City of Bellevue

Preliminary Engineering Design Report for Reservoir Structural/Seismic Evaluation

Subject: Reservoir Structural/Seismic Evaluation
Final Report

RESPONSES TO QUESTIONS AND COMMENTS
Draft Report for Reservoir Structural Seismic Evaluation

Lake Hills South - Gouged Shell Plate

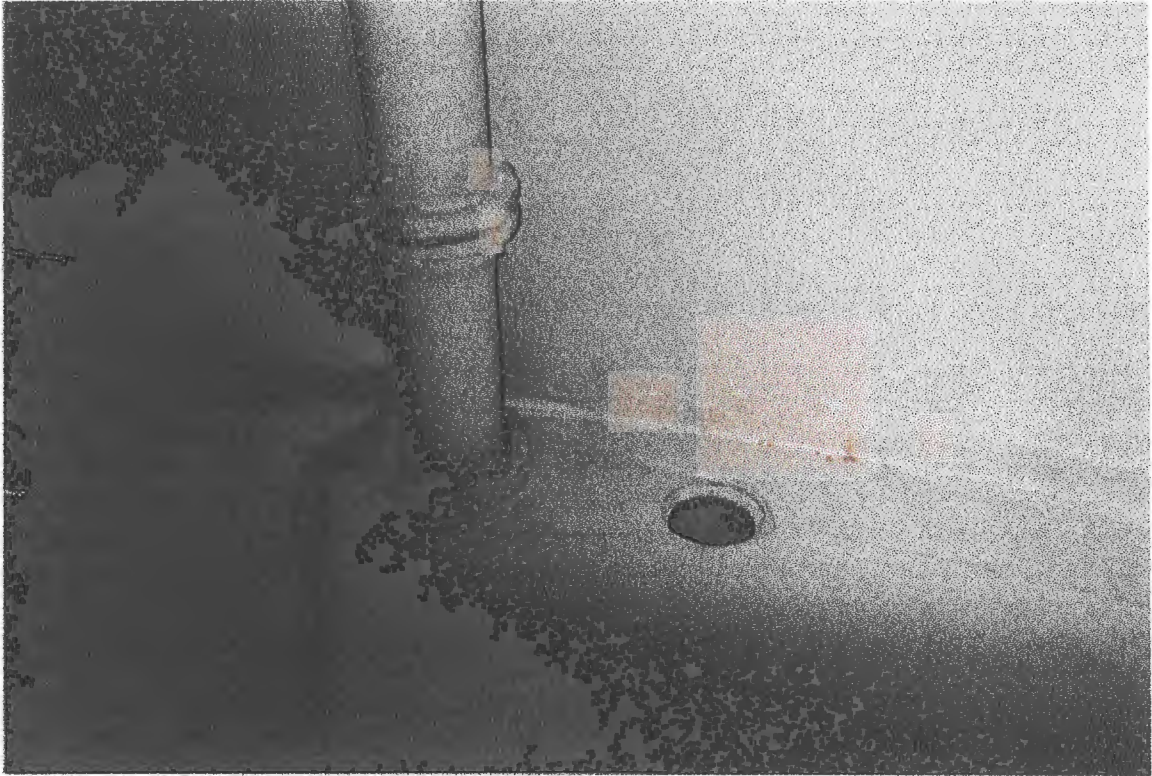
COMMENT 2 The gouges in the tank picture look significant, but were not addressed in the text of the report. Are they significant? Were they measured? Should bollards be installed to prevent future damage?

RESPONSE: These gouges are significant and should be repaired. Bollards should be installed to prevent future damage. This was clarified in the "General Reservoir Condition" subsection of Section 8 and noted in Section 11.
